**RE: Sydney Grammar School, Weigall Sports Complex: State Significant Development (SSD-10421):  
Response to Condition B1**

This letter on the Sydney Grammar School Weigall Sports Complex (SSD-10421) is written on behalf of Sydney Grammar School. It responds to SSD-10421 Condition B1 which states:

**Figure 1: Southern boundary setback design amendment to address Condition B1**

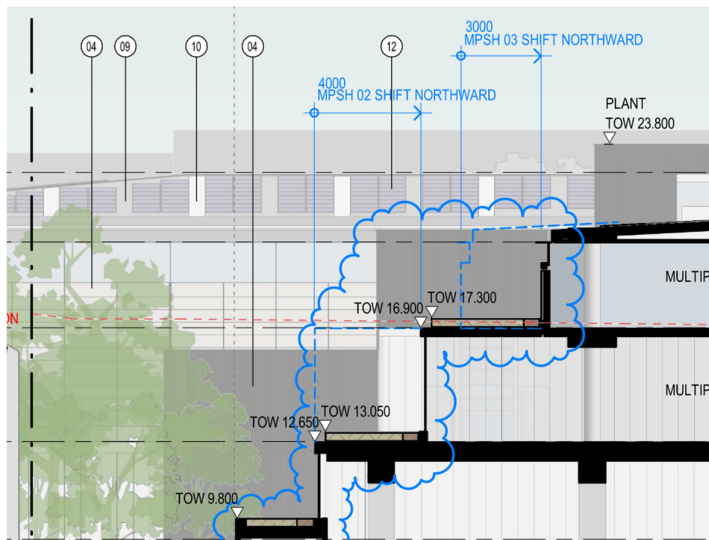
- (a) relocate the floor plate of the portion of Level 1 accommodating Multi-Purpose Sports Hall 2, further northward by **4m**, to increase the setback of this part of Building 1 to the southern boundary;

- (b) relocate the floor plate of the portion of Level 2 accommodating Multi-Purpose Sports Hall 3 further northward by **3m**, to increase the setback of this part of Building 1 to the southern boundary;

1. Level 1, Multipurpose Sports Hall 2 (see **Figure 1**):
  - Relocated **4m** northward to increase the southern boundary setback
  - Non-trafficable landscaped terrace to the new setback area
2. Level 2, Multipurpose Sports Hall 3 (see **Figure 1**):
  - Relocated **3m** northward to increase the southern boundary setback
  - Non-trafficable landscaped terrace to the new setback area
